### STAFF REPORT ADDENDUM

SE 2012-MA-018

**APPLICANT:** Agape Health Management, Inc.

**PROPOSAL:** A special exception to permit a day care center for up to 150 adult participants within a building of approximately 23,622 square feet (sf) and to permit an associated office use within a separate single-family detached structure of approximately 4,060 sf.

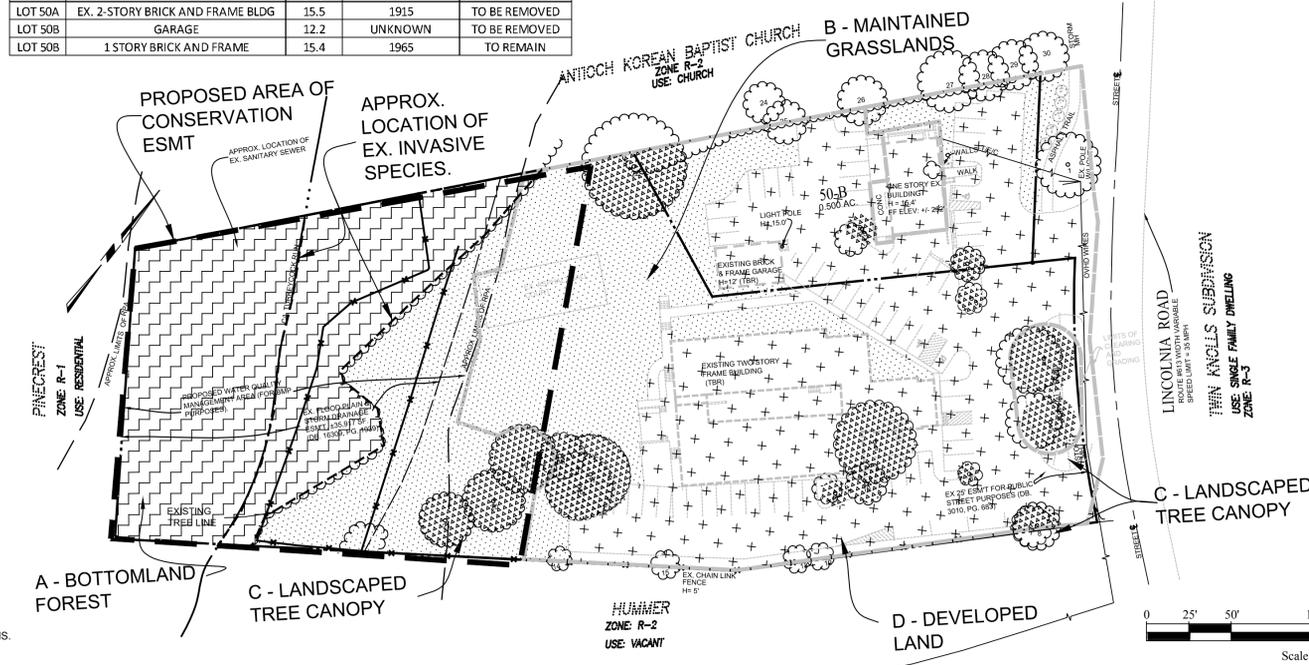
**Recommendation:** The applicant should revise the EVM (sheet 7) and the SE Plat (sheet 11) to state that reforestation planting will occur within the RPA in areas of the bottomland forest that has been identified as have a fair to poor condition, contain sparse vegetation, where invasive species will be controlled, and in areas that do not contain forest cover shall be reforested in accordance PFM 6 -1311.3. If any 10-year canopy is going to be claimed for reforestation, it shall be clearly depicted for stormwater BMPs on the SE plat and noted in table 12.10. In addition, it is strongly recommended that the applicant agree to a development condition for a reforestation plan to be submitted at site plan to include the following:

**LANDSCAPE PLAN**

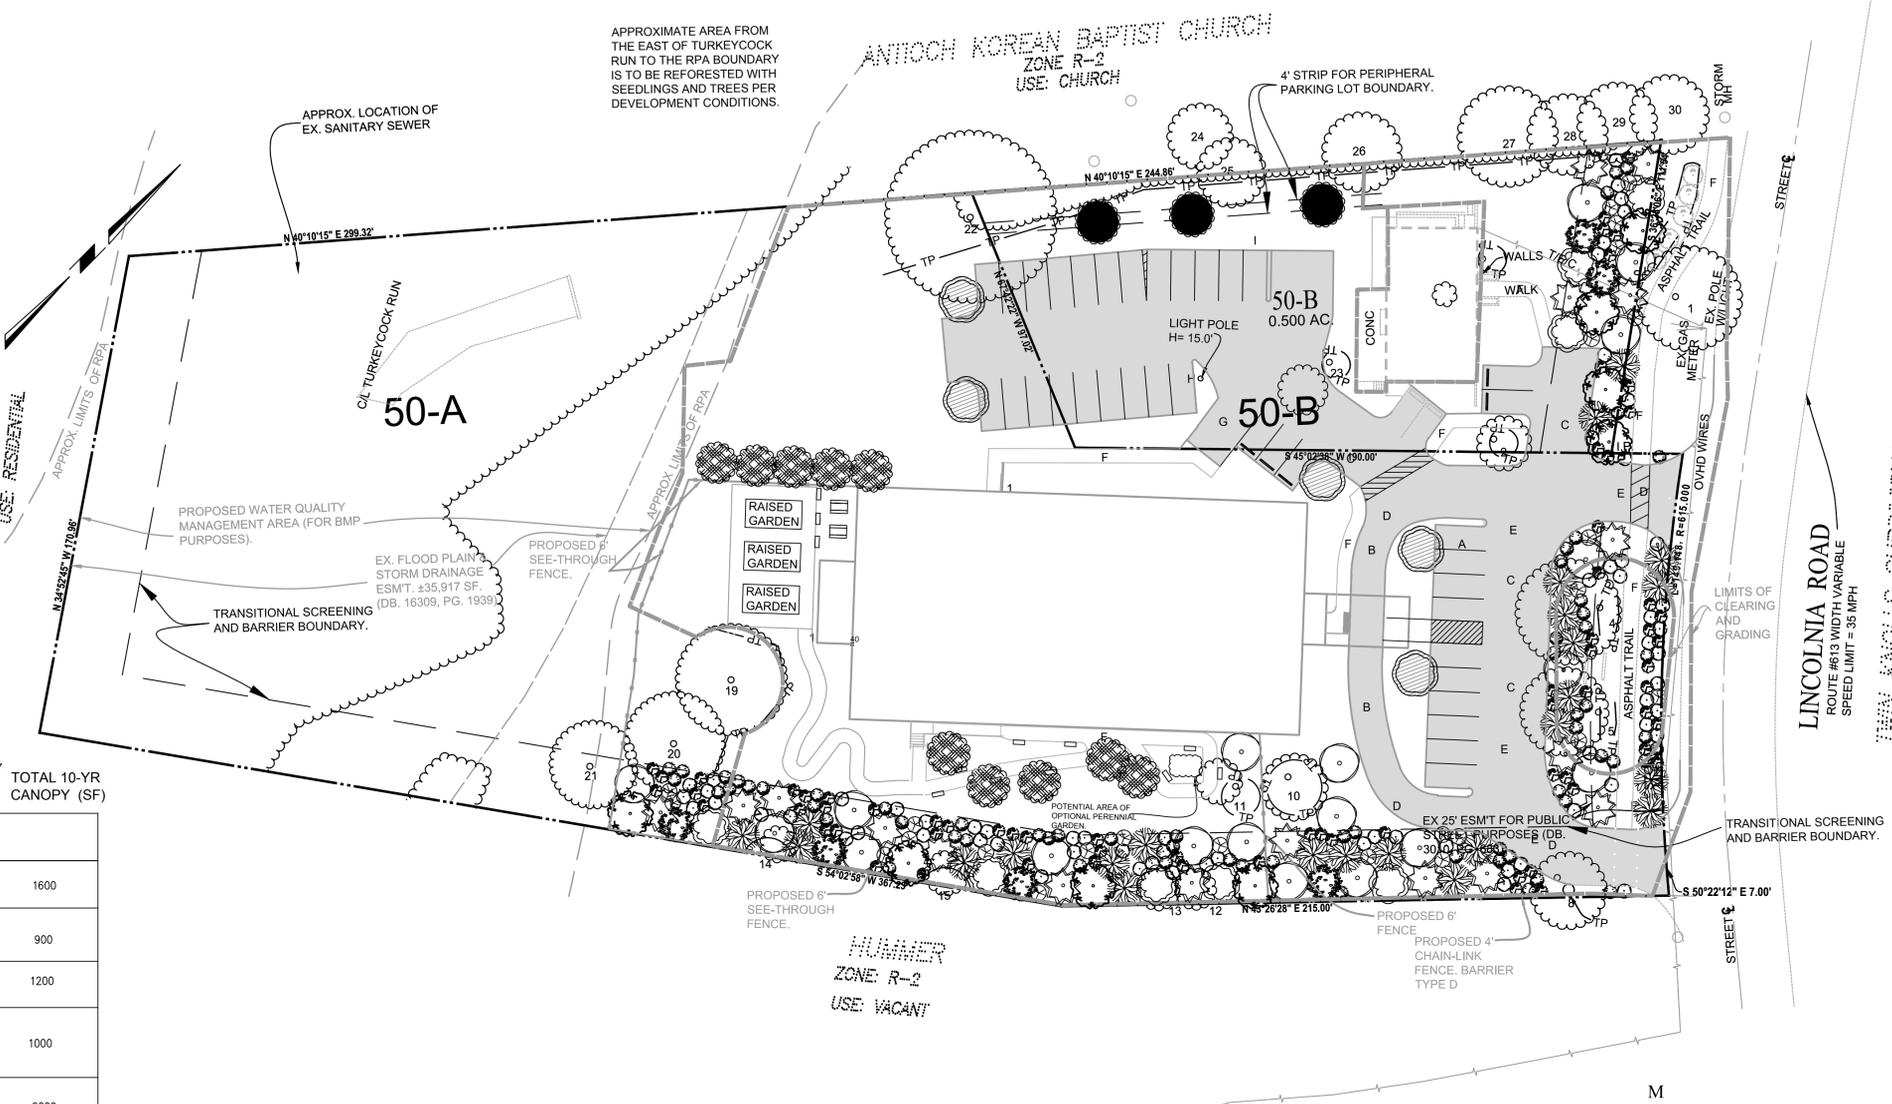
**1. Comment:** The applicant is requesting to modify/waive the transitional screening (sheet 8) that is required along the northeast, southeast, and southwest sides of the site and notes that existing screening, proposed landscaping, and barriers will be used to satisfy the requirement. In addition to the zoning ordinance requirement for transitional screening, the Comprehensive Plan for the Lincolnia Planning District (L-1 Pinecrest) states that sites being redeveloped should provide screening and buffering to minimize the impact on adjacent areas planned for low density residential use. The following items are still outstanding regarding transitional screening modifications/waivers:

*The proposed trail remains where it was relocated previously so that it does not encroach into the transitional screening yard. Landscaping calculations have been revised on Sheet 10 - per mark-ups and meeting comments (6/11/2013) - to support the transitional screening schedule and trees shown on Sheet 9. The fence, a 6' see-through fence, as specified by the County, has been called out on Sheet 9.*

*A transitional screening matrix, which calculates the 10-year canopy area required and provided, has been provided on Sheet 10; no extra planting is required for this lot line. The fence, a 6' see-through fence, as specified by the County, has been called out on Sheet 9. There is no detail provided for this fence so as leave flexibility in the decision, as discussed during the 6/11/2013 meeting. This fence extends until the edge of the proposed building. It is hereby requested that a waiver be granted for the barrier requirement along the remainder of the lot line. Waiver and narrative on Sheet 8. Proposed fence termination location shown on Sheet 9.*

*The above note has been added to Sheet 9, “where applicable” has been removed from the note.*

*The 10-year canopy credits have been revised and adjusted according to the mark-up and discussion on 6/11/2013. See Sheet 9 for new planting schedule and Sheet 10 for the supporting calculations for transitional screening, interior parking lot screening, peripheral parking lot screening, and proposed landscaping to meet the 10-year canopy for the subject site.*

*The applicant has added 3 proposed raised gardens for the facility participants. Additional landscaping has been placed around the passive recreation area for this facility. An area reserved for a potential perennial garden has been reserved within the usable open space and is depicted on Sheet 9.*
